**Wayne County (Environmental) – Improvements Permit**

**Permit No:** 14070104092  
**Status:** INCOMPLETE

REF. NO. <u>5278</u>	MOBILE HOME IMPROVEMENT PERMIT	DATE <u>10-20-93</u>	TWP. <u>Fork</u>	ID. NO. <u>07.1007AC 39</u>
REQUESTER <u>Benton &amp; Associates</u> <u>107 Shamrock Rd.</u> <u>Goldsboro NC</u>	OWNER <u>Some</u>		TELEPHONE <u>735-3579</u>	
SPECIFICATIONS <u>3 BR House (132 Pote Circle)</u>		WATER SUPPLY: PUBLIC <input checked="" type="checkbox"/> ; PRIVATE <input type="checkbox"/>		
LOCATION/DIRECTIONS <u>SR1007 / Quaker Neck Ept. / Sect 3 / Lot 39</u>				
FEE <u>90-</u>	LAND SIZE	SIGNATURE OF OWNER OR AUTHORIZED AGENT <u>Richard M. Benton</u>

PRELIMINARY PLOT PLAN FOR

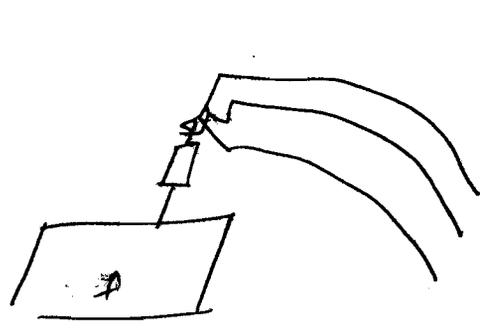
- SEE PLOT PLAN
- \* Install system in location exactly as shown on plot plan.
  - \* Nitrification lines no deeper than 18 inches at any point.
  - \* House must be raised to get gravity flow to tank - or it may need to be moved back.
  - \* The dirt on the ditch bank should be leveled off before septic system installation.

CONTROVERSIAL SITUATION  
Contact Sanitarian before  
installing system.

NOTE: the location of  
the "D" Box AS  
shown

Note!  
The dirt on the  
Ditch Bank should  
be pulled away  
& leveled before  
Septic System  
Installation

\*Nitrification Lines  
No deeper than  
18 inches At any point.

\*House Must Be Raised  
or moved Back If  
Gravity flow Cannot  
Be achieved.
